Intended for
UPC Renewables Australia Pty Ltd

STUBBO SOLAR FARM AMENDMENT REPORT

Project name **Stubbo Solar Farm**
Project no. **318001132**
Recipient **UPC Renewables Australia Pty Ltd**
Document type **Amendment Report**
Version **V1**
Date **01/06/2021**
Prepared by **Belinda Sinclair / Taylor Hancock / Jon Williamson**
Checked by **Jon Williamson**
Approved by **Jon Williamson**
Description **Amendment Report for the Stubbo Solar Farm project.**

Figure 2-1 | Update of EIS Figure 3-3 to show additional non-associated property ('R11')

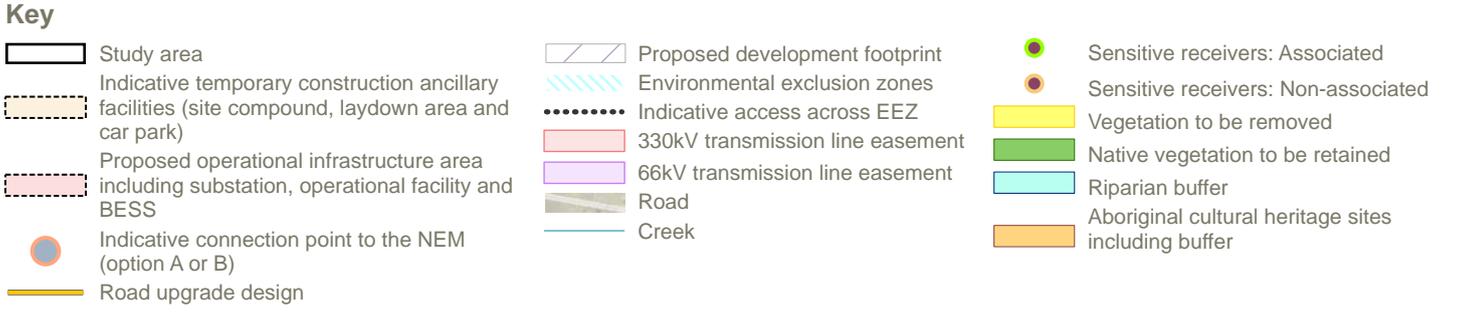
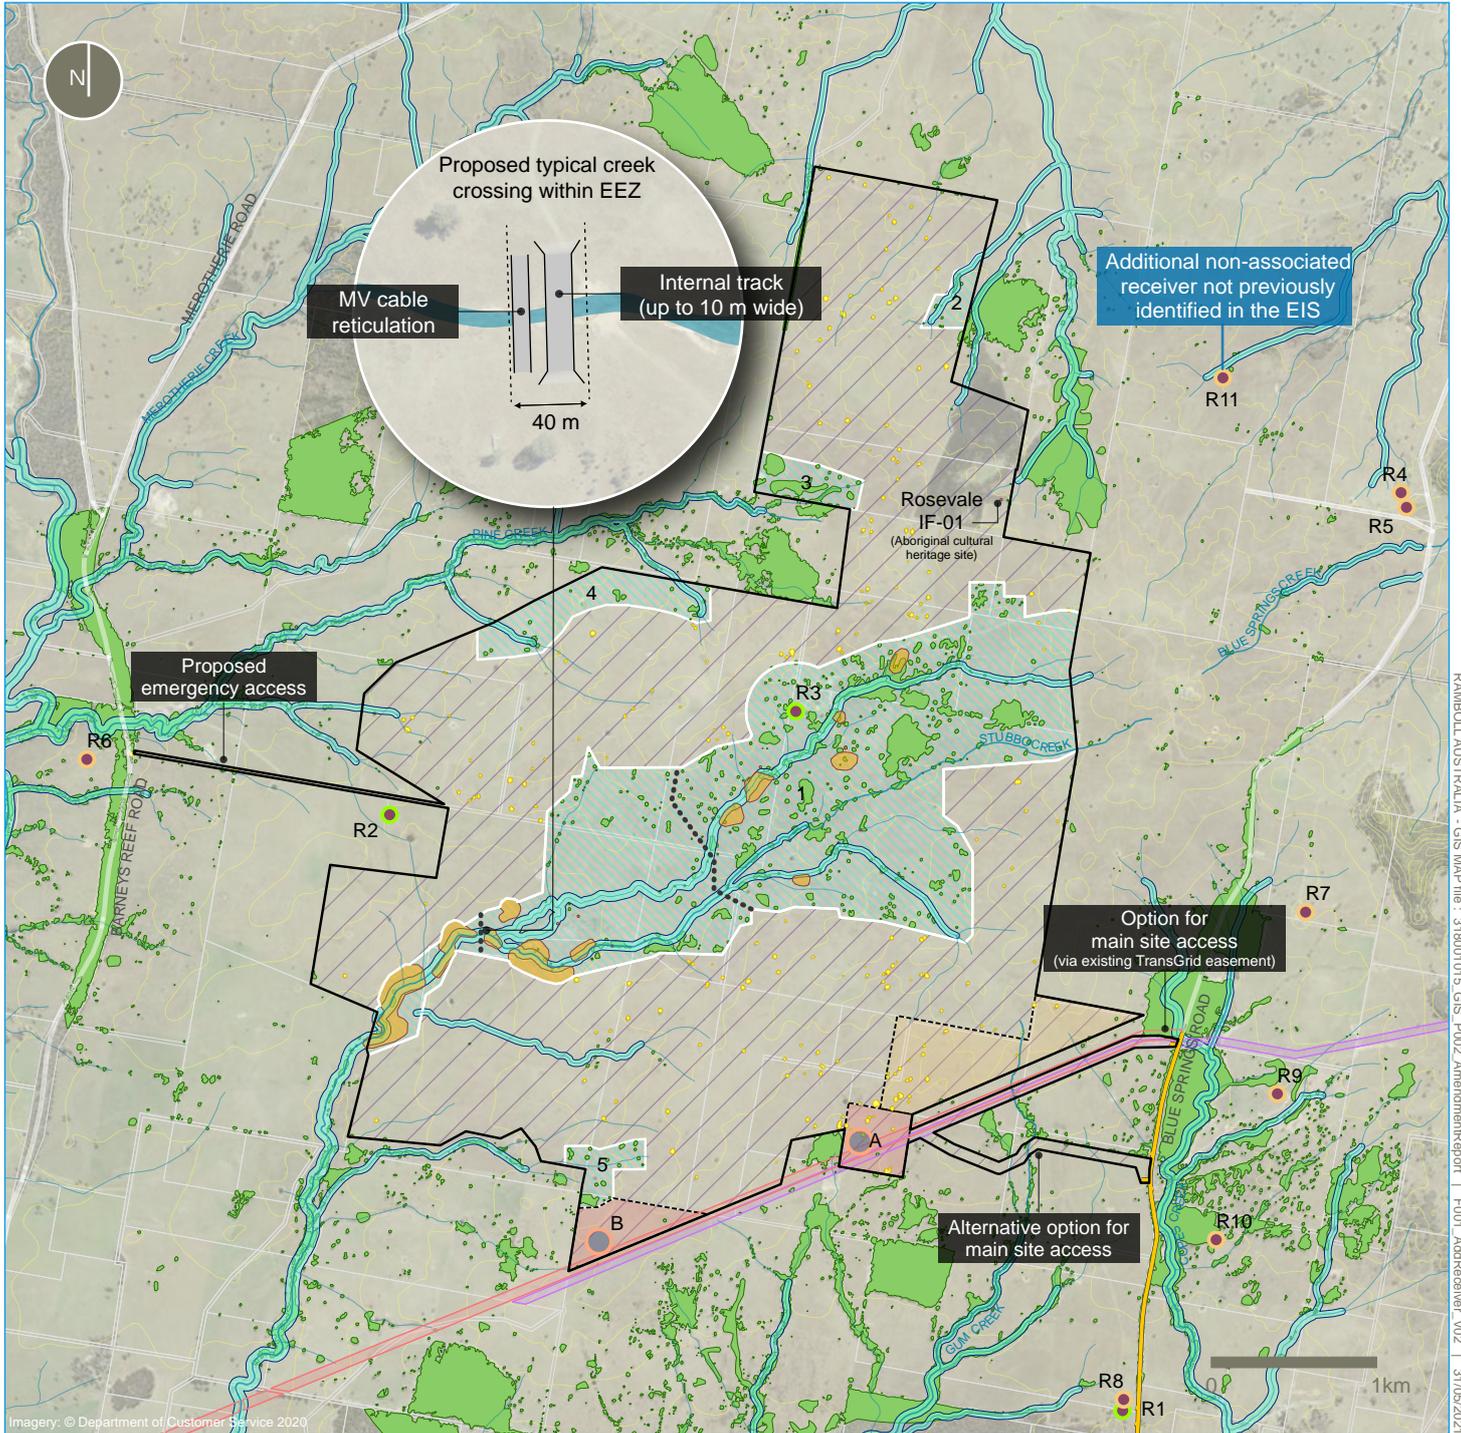
Review of the EIS during the exhibition period noted that one non-associated property was not shown on the key environmental and other land use constraints figure in the EIS (Figure 3-3 in the EIS).

Contact with the landholder was established after the EIS was lodged in December 2020 and this figure has now been updated. The additional non-associated property is identified as 'R11' in **Figure 2-1**.

Figure 2-2 | Update of EIS Figure 3-3 to clarify use of the development footprint within the TransGrid easement

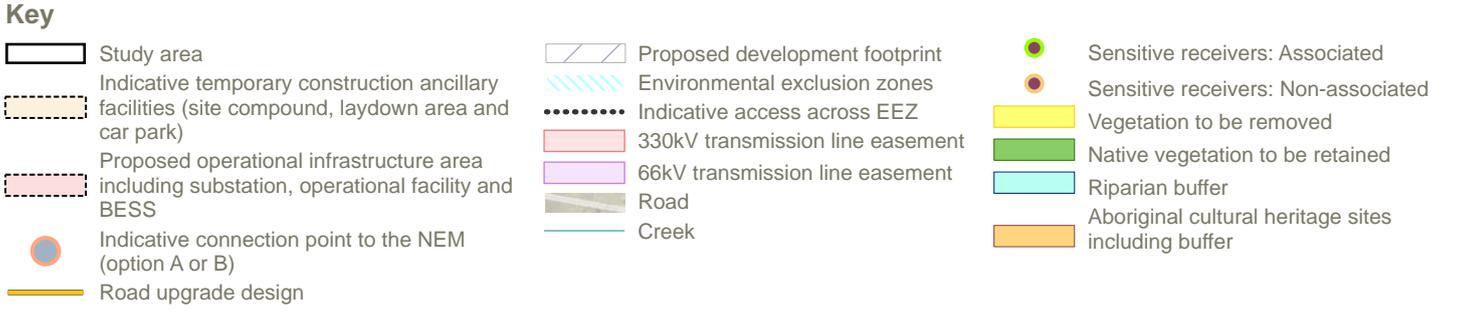
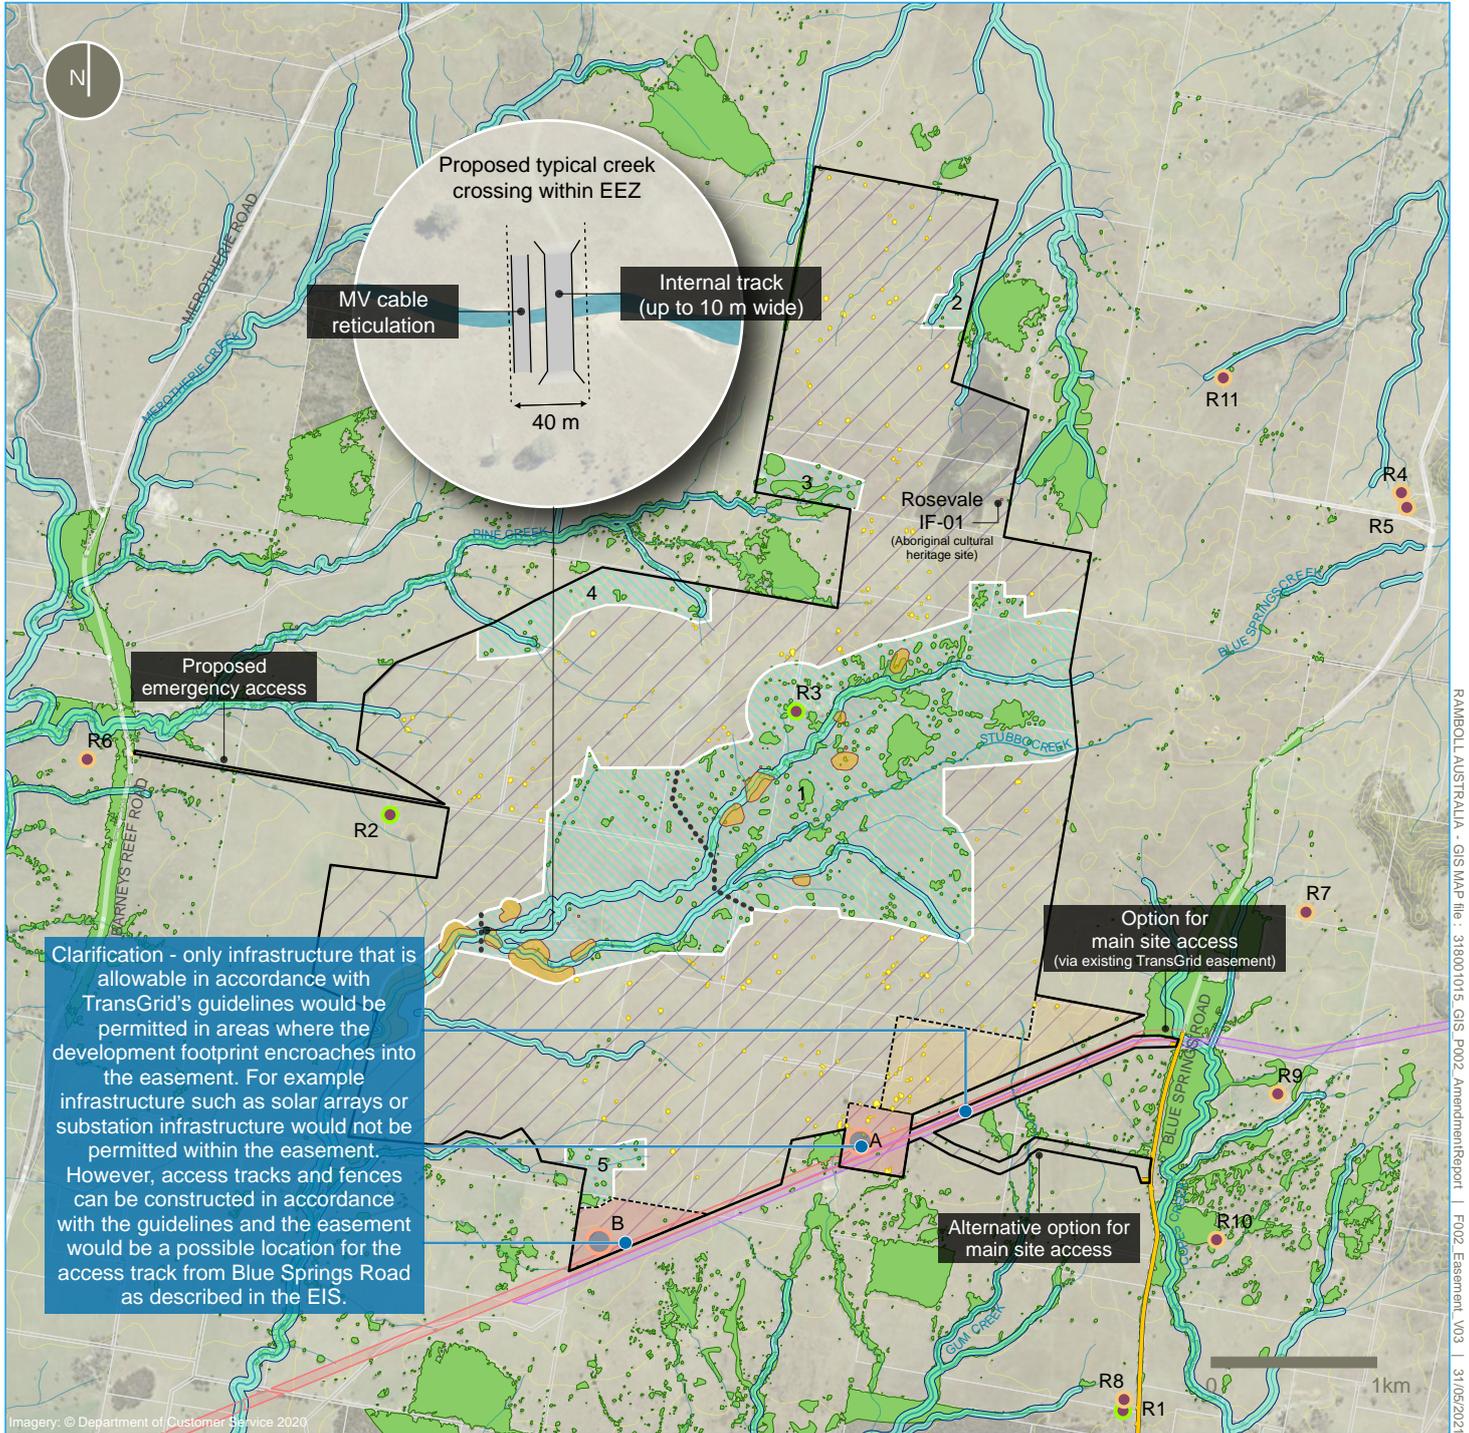
Review of the EIS during the exhibition period noted that the development footprint in the key environmental and other land use constraints figure in the EIS (Figure 3-3 in the EIS) was shown as encroaching into the existing easement for the 330 kilovolt and 132 kilovolt transmission lines on the western side of the development footprint.

The development footprint was shown as encroaching in three locations, including the proposed access track and the indicative substation location options ('A' and 'B'), without clarification as to the intended use of the development footprint in these areas.

An updated figure is provided in **Figure 2-2** to show that only infrastructure that is allowable in accordance with TransGrid's guidelines or as specifically required by TransGrid would be permitted in areas where the development footprint encroaches into the easement. For example, infrastructure such as solar arrays or substation infrastructure would not be permitted within the easement. However, access tracks and fences/gates can be constructed in accordance with the guidelines and the easement would be a possible location for the access track from Blue Springs Road as described in the EIS.

Figure 2-3 | Indicative layout of subdivision area for switchyard

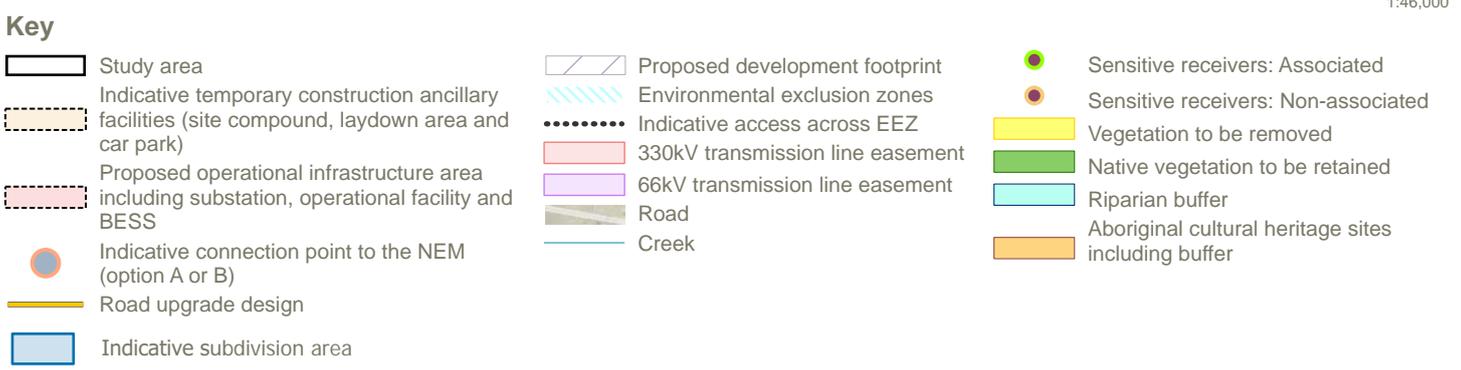
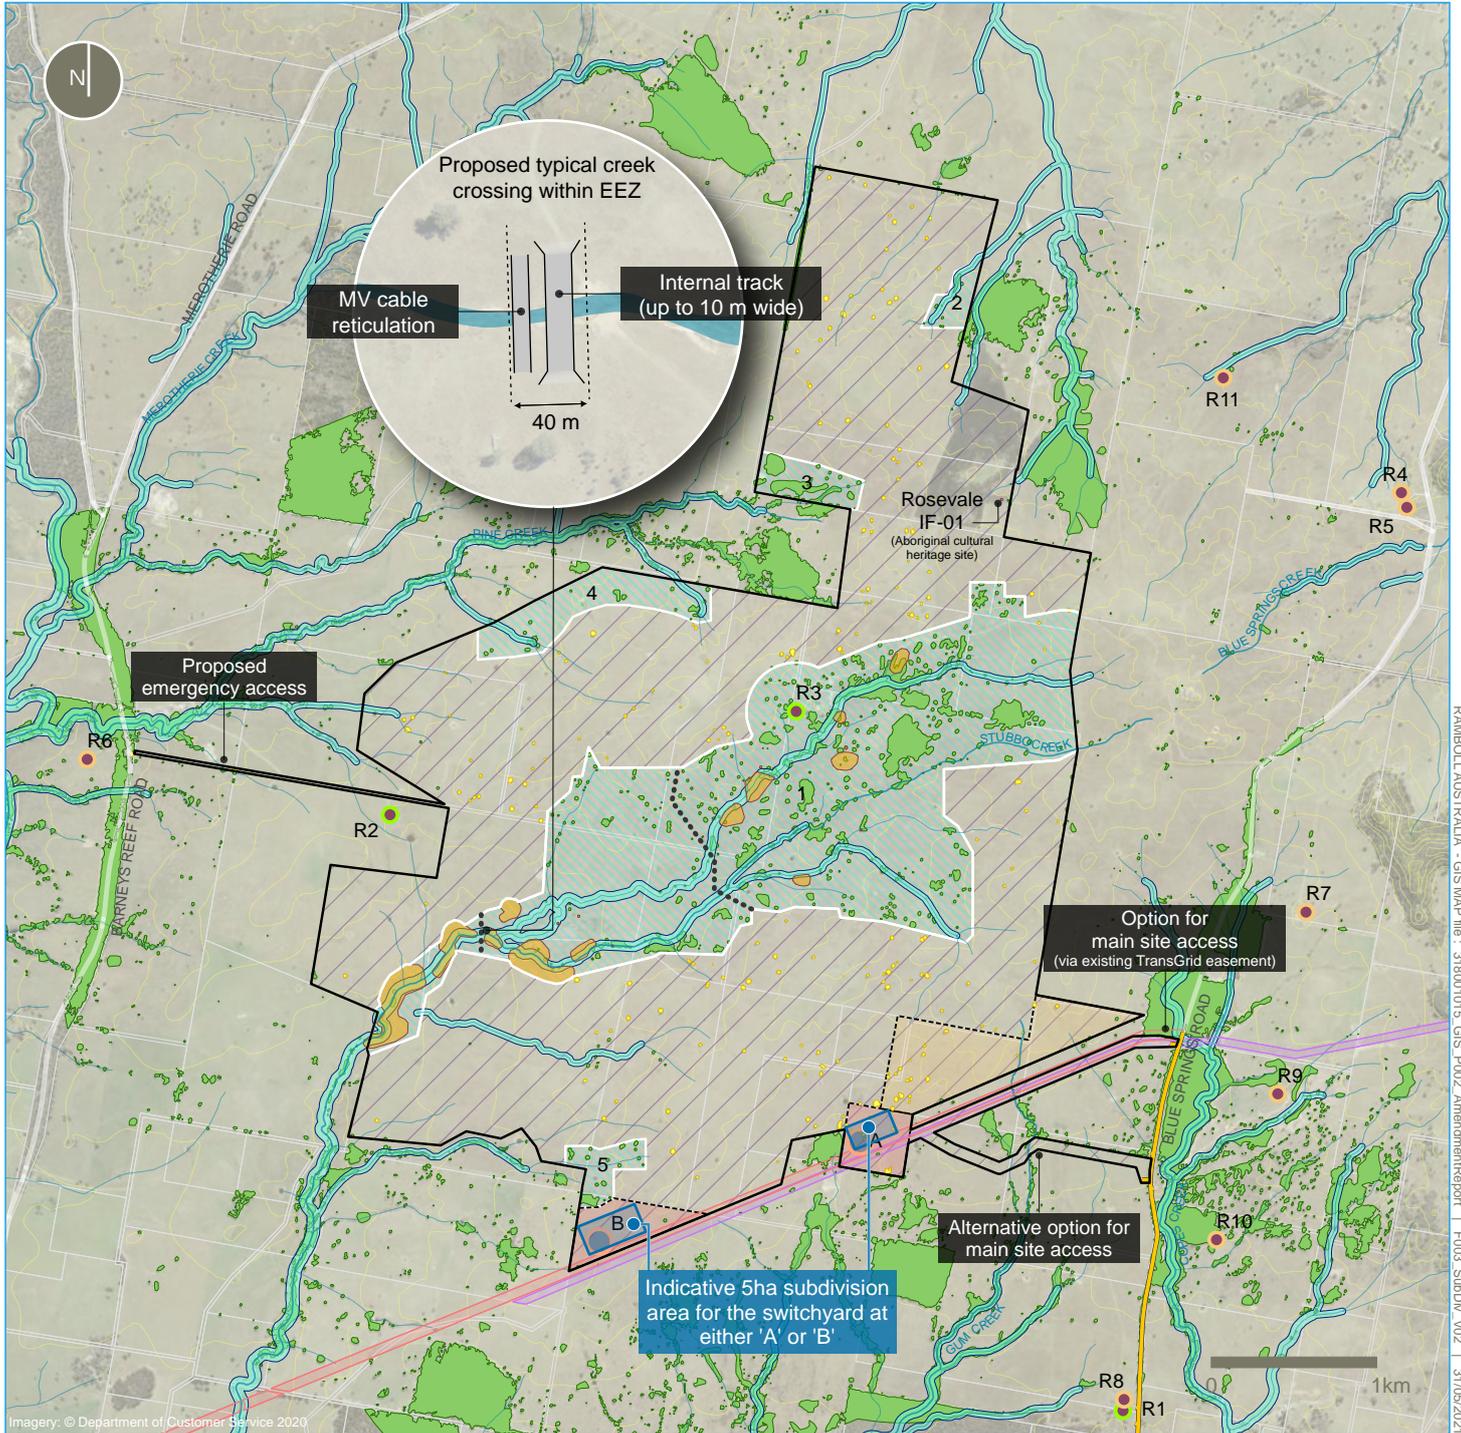
A subdivision for the purpose of the outdoor switchyard component would be required within the substation area, as specifically required by TransGrid for connection to Line 79. TransGrid requires transfer of the land title for this subdivided land during the construction of the switchyard. A subdivision is not required for other components within the substation area.

An indicative layout of the outdoor switchyard area based on an example of similar infrastructure at the New England Solar Farm, is provided in **Figure 2-3**.

Figure 3-1 | Extent of the proposed Blue Springs Road upgrade

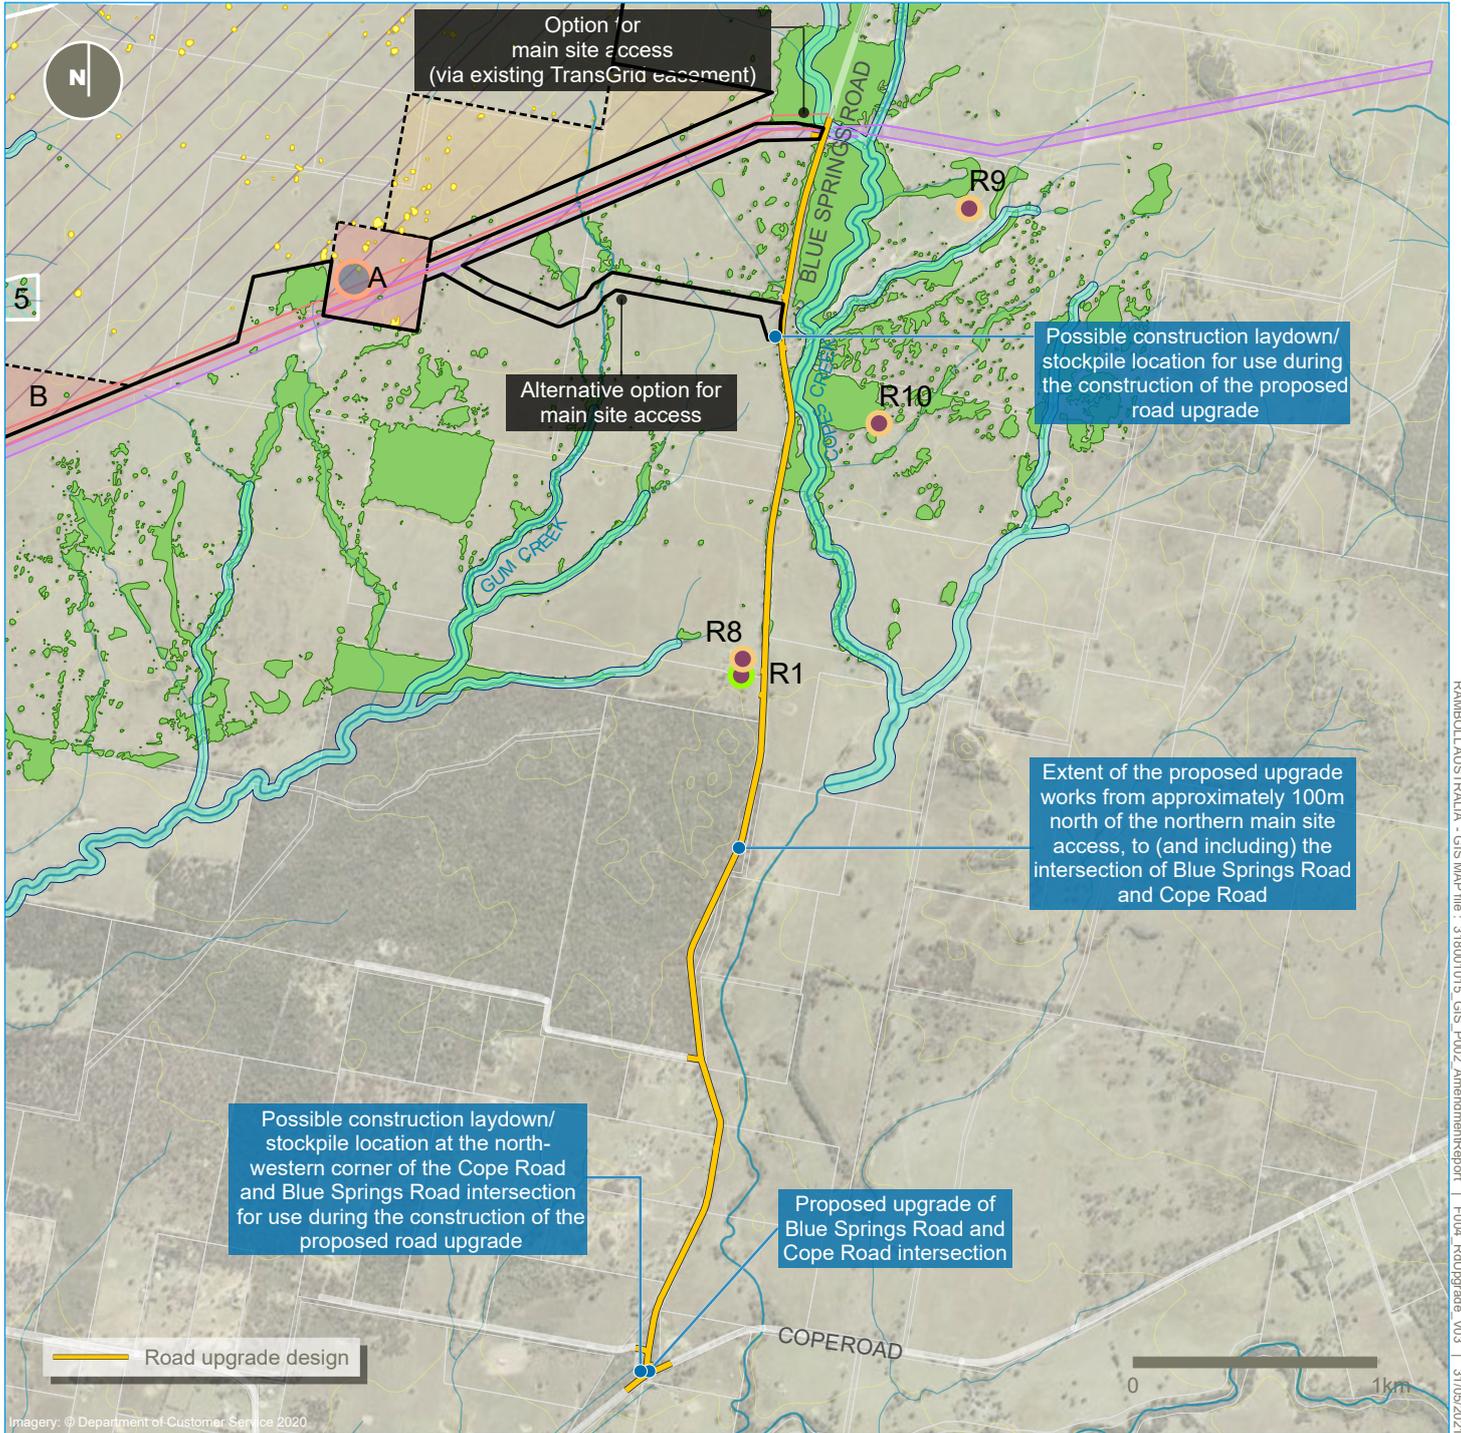
The extent of the proposed upgrade is shown in **Figure 3-1** and concept design drawings are provided in **Appendix 2**.
